# BUILDING CODE OF AUSTRALIA SECTION C, D & E COMPLIANCE AUDIT REPORT

Residential Flat Building

97 Queenscliff Road, Queenscliff

REPORT NO. ► 14094 Rev.00

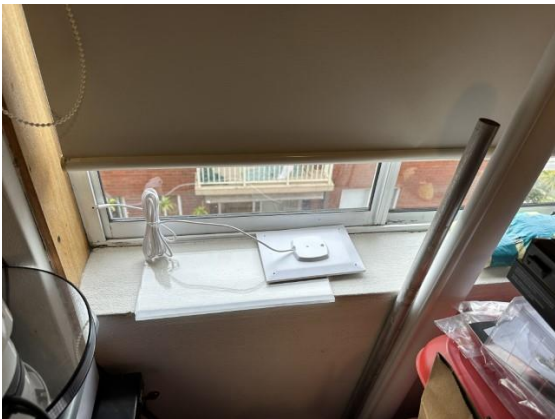
Item	Location	Photo	Details of Defect & Nominated Breach	Recommended Remedial Works
8.	TYPICAL ISSUE Stairs		<p>BCA clauses D3D14 and D3D15</p> <p>There are no non-slip nosings to the stairs and the stair landings.</p>	Non slip nosing should be installed in accordance with BCA clauses D3D14 and D3D15.
9.	Unit 1 Ground		<p>BCA clause D3D29</p> <p>The bedroom window has not been fitted with a window restrictor in accordance with this clause.</p>	A window restrictor should be installed to the bedroom window as required by clause D3D29.

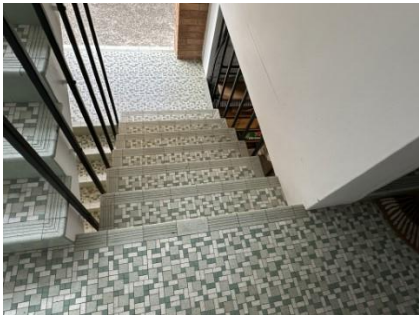
Item	Location	Photo	Details of Defect & Nominated Breach	Recommended Remedial Works
23.	Unit 15 Both bedrooms		<p>BCA clause D3D29</p> <p>The bedroom window has not been fitted with a window restrictor in accordance with this clause.</p>	<p>A window restrictor should be installed to the bedroom window as required by clause D3D29.</p>
24.	Front Block Commons Third Floor (top)		<p>BCA clause D3D18</p> <p>The balustrade at the landing was less than 1m high.</p>	<p>The balustrade should be upgraded to be a minimum 1 metre high to comply with BCA clause D3D18 and AS 1170.1 - 2022.</p>

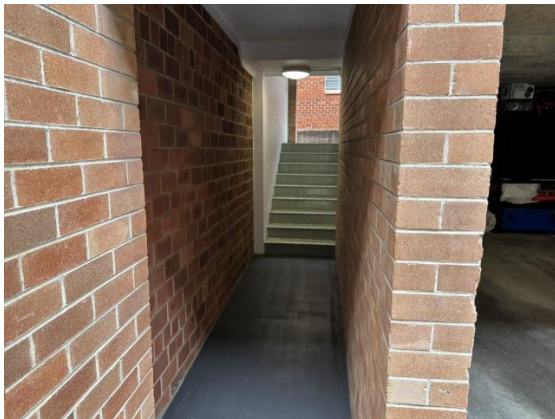
42.	Rear Block Level 1		<p>BCA clause E4D5</p> <p>There was no exit sign installed at the exit location at ground floor.</p>	<p>An exit sign should be installed at the ground floor in accordance with BCA clause E4D5 and AS/NZS 2293.1 – 2018.</p>

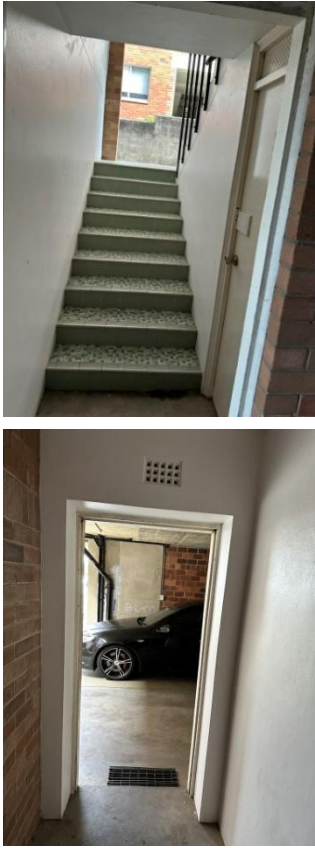
Item	Location	Photo	Details of Defect & Nominated Breach	Recommended Remedial Works
48.	Ground Level Path of Travel to Stair		<p>BCA clause D3D8</p> <p>The path of travel from the stair to external is less than 1m, only 940mm.</p>	<p>Due to the minor nature of the non-compliance and the low occupant load of this area I do not consider that upgrade works are required as the minor reduced width would be compliant with the performance requirement D1P6.</p>
49.	Ground Level Stair up to L1 Main Entry		<p>BCA clause D3D8</p> <p>The path of travel on the stair is less than 1m, only 950mm.</p>	<p>Due to the minor nature of the non-compliance and the low occupant load of this area I do not consider that upgrade works are required as the minor reduced width would be compliant with the performance requirement D1P6.</p>

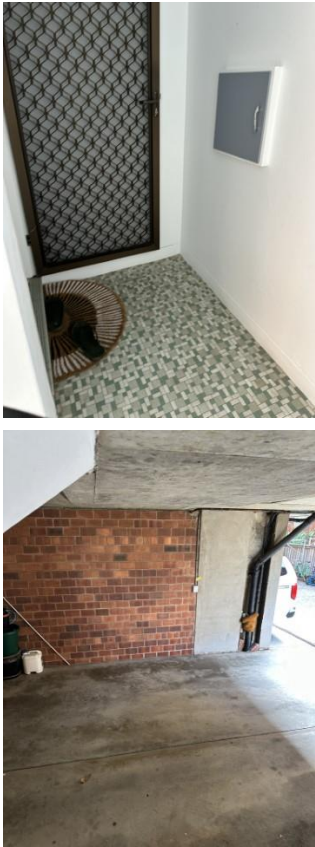
Item	Location	Photo	Details of Defect & Nominated Breach	Recommended Remedial Works
51.	Roof level		<p>BCA Specification 5.</p> <p>There was a hole in the wall of the riser that was not fire sealed.</p>	<p>The hole in the wall of the riser should be fire sealed to comply with BCA Specification 5.</p>
52.	Roof level		<p>BCA clause C4D15</p> <p>Within the roof area there were service penetrations that were not fire sealed where they came through the ceiling. The ceiling appears to be a fire rated ceiling as two layers of fire rated plasterboard have been provided.</p>	<p>A fire contractor specialising in fire rating of service penetration should gain access to the roof space and fire rate all service penetrations within the roof space that penetrate through the ceiling, so that the penetrations achieve a minimum 60 minute incipient spread fire rating.</p>
